Avolites LTD Engineering Change Notice

ECN title	Quartz Audio Input Timing Capacitor		
ECN Number	ECN-200		
Related Product(s)	All Quartz SN QTZ-0010 to QTZ-367		
Date / Author	04/06/2015	JB Toby	
Reasons for ECN	Audio input may not function (no audio seen in Trigger workspace)		
Parts required	None		
Tools required	Pozi drive no 1, small tipped soldering iron		
Estimated time	10 Minutes

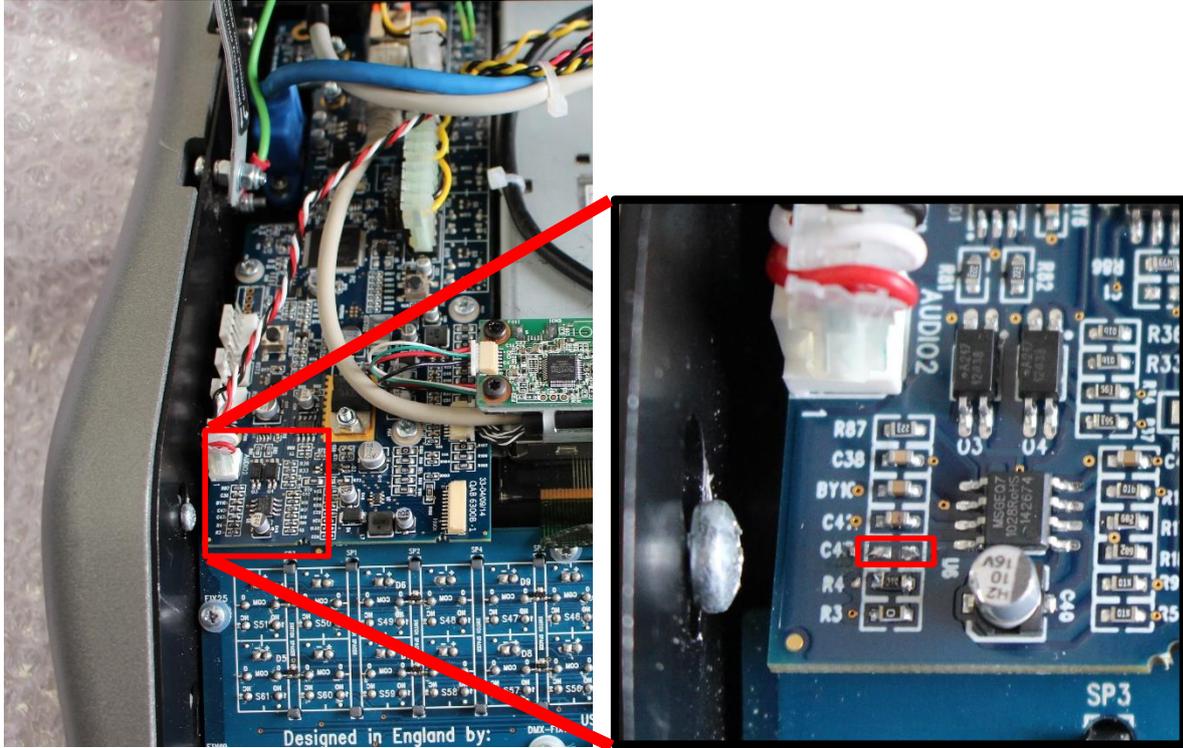
Open the console by unscrewing the front screws (Pozi No 2)

Open up the front panel and secure using the stand (right hand side), the stand engaged in to the side of the front panel.

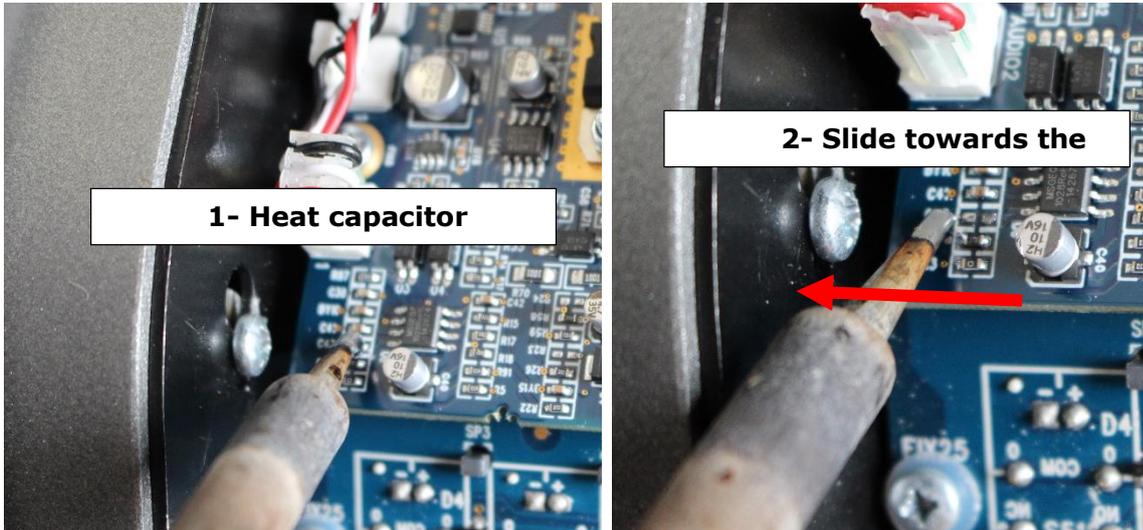
Locate C43 on the QAB board (see picture)

Using a soldering iron remove this capacitor,

This is best done by putting a small amount of solder onto the soldering tip and then holding this against the centre of the capacitor as shown, After a few seconds the capacitor should come off the board by wiping the soldering iron towards the edge of the board

Make sure that the capacitor is removed from the board,
